SEPTIC: IMPROVEMENT PERMIT / AUTHORIZATION TO CONSTRUCT / OPERATION PERMIT / EXISTING SYSTEM

PERMIT # OSWP 2025-71211

SITE ADDRESS: 211 Marble Rd, Statesville, NC 28625

System Description: VPPBPS - PM (IIIbe)

SITE LAYOUT

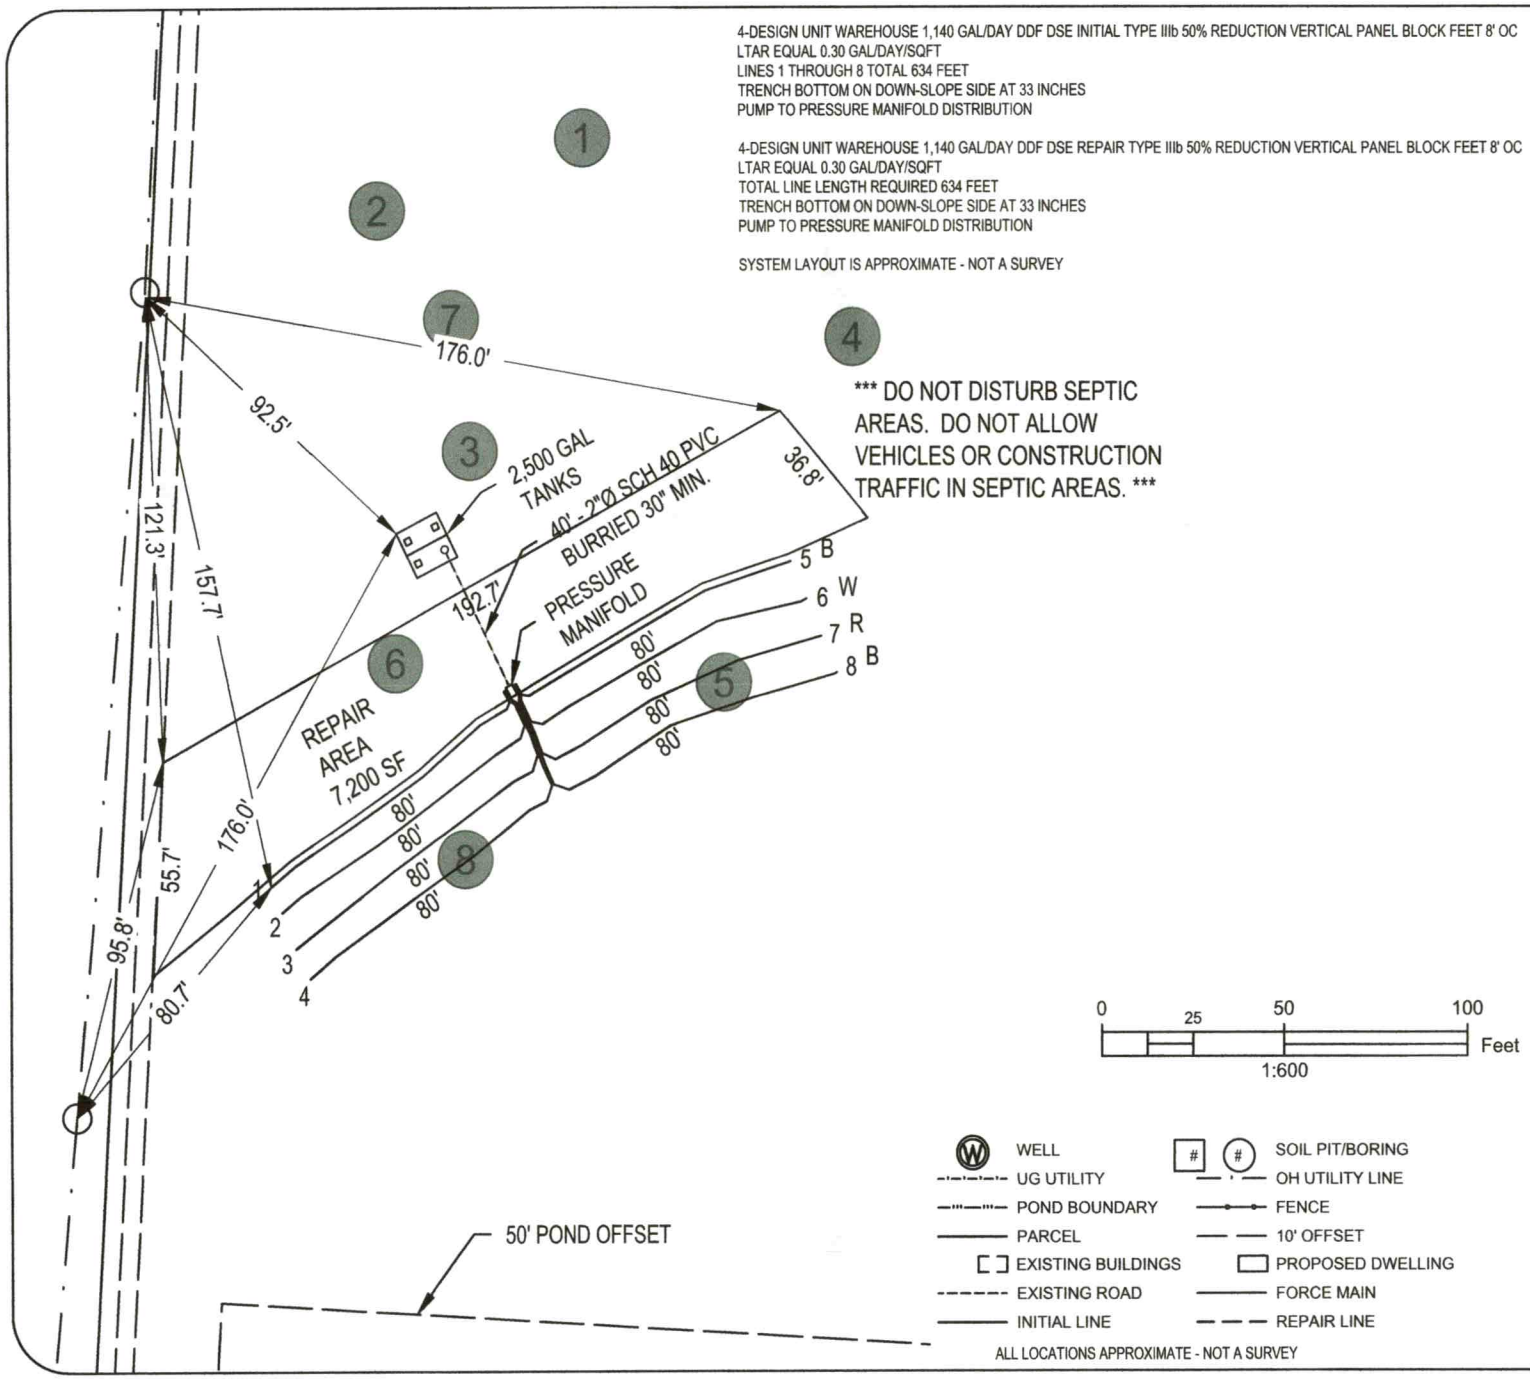
Comments / Conditions: Requires larger than a 1500g septic tank.

Do not pave, grade, drive, park, or bury utilties in drainfield.

1834 Gallon tank minimum required - see design showing 2500g.

PRIOR TO ISSUING OP:

REMOVE ALL EQUIPMENT & TRAILERS FROM ENTIRE REPAIR AREA

SHAVE BACK DIRT MOUND TO 10' OR GREATER FROM ALL DRAIN LINES, DIVERT DRAINAGE OFF OF MOUND AWAY FROM SYSTEM

2500 gal Tanks
Lines
PM
SH 3/28/25

Supply line 30" - SH

Buildings to be moved off repair

- FLOATS
- ALARM
- ELECTRICAL
- PRESSURE HEAD
